# Access Compliance Report

## Public Rights-of-Way

### (Curb Ramps)

Intersection ID: 10036062	Main Street: RIVERGATE_PY	Cross Street: N/A	Location: NE
ADA ID: 2DB5704DE3FF	Ramp Type: Perp	Initial Pass/Fail: Fail	Overall Compliance: No
Severity Score: 13.75			
Codes/Mitigation Info/Possible Solution		Field Measurements/Component Compliance

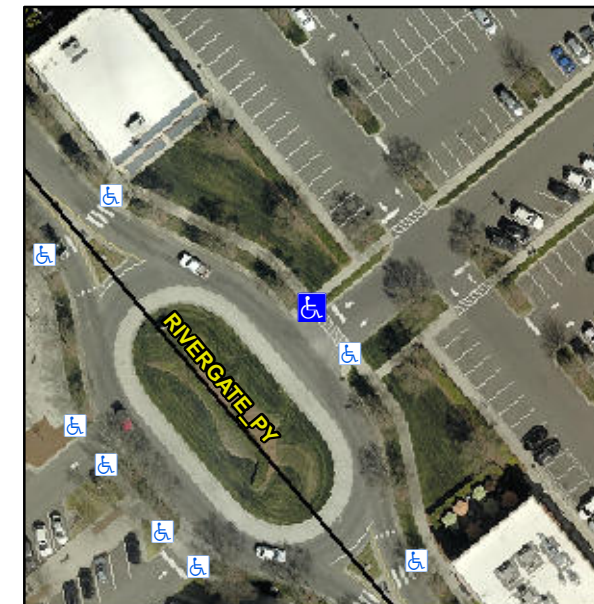
**Not Found, R304.2.2, R304.5.3**

Compliance	Description	Data	Compliance	Description	Data
N/A	Ramp Length (in)	49.0	No	Ramp Slope (%)	9.4
Yes	Ramp Width (in)	70.0	No	Ramp XSlope (%)	2.9
N/A	Flare Type LT	N/A	N/A	Flare Type RT	N/A
N/A	Flare Slope LT (%)	N/A	N/A	Flare Slope RT (%)	N/A
N/A	Flare Traversable LT?	N/A	N/A	Flare Traversable RT?	N/A
N/A	Landing Length (in)	N/A	N/A	DWS Provided?	N/A
N/A	Landing Width (in)	N/A	N/A	DWS Contrast?	N/A
N/A	Landing Slope (%)	N/A	N/A	DWS Length (in)	N/A
N/A	Landing X Slope (%)	N/A	N/A	DWS Full Width?	N/A
N/A	Landing Curb? (Y/N)	N/A	N/A	DWS Offset (in)	N/A
N/A	Shared Landing?	N/A			
N/A	Gutter Ponding?	N/A	N/A	Gutter Slope (%)	N/A
N/A	Gutter Lip Ht (in)	N/A	N/A	Gutter X Slope (%)	N/A
N/A	Painted X Walk1?	Yes	N/A	Painted X Walk2?	N/A
	X Walk 1 Direction	To SE		X Walk 2 Direction	N/A
N/A	X Walk 1 Width (in)	62.0	N/A	X Walk 2 Width (in)	N/A
	X Walk 1 Slope (%)	1.0		X Walk 2 Slope (%)	N/A
	X Walk 1 X Slope (%)	0.2		X Walk 2 X Slope (%)	N/A

**Remove & Replace Entire Ramp.**
